# JAMESTOWN S'KLALLAM TRIBE

RE: Puget Sound Nutrient General Permit (PSNGP) Preliminary Draft Comments

## General Comments on Puget Sound Nutrient General Permit

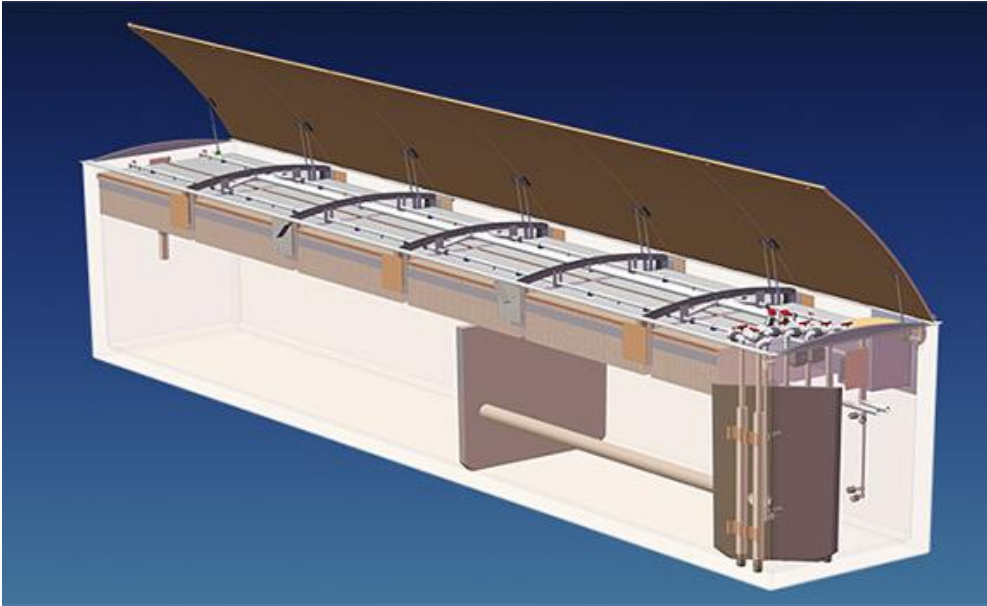
5. *Do reviewers have suggestions for "reasonable investments" at small (<3 MGD), medium (3-10 MGD) and large (>10 MGD) that could be used to separate the two tiers of optimization actions required by this permit?* Two items: 1) a full educational campaign that makes all aware that every drop of water they use will eventually end up in the Puget Sound and affect our water quality and all that live in that environment. With stickers at every water source and products that are used with water, thus ending at the WWTP. 2) Another would be the installation of a living system.

<https://twitter.com/suez/status/976819715984318464/photo/1> These could be as large or small as space allows.
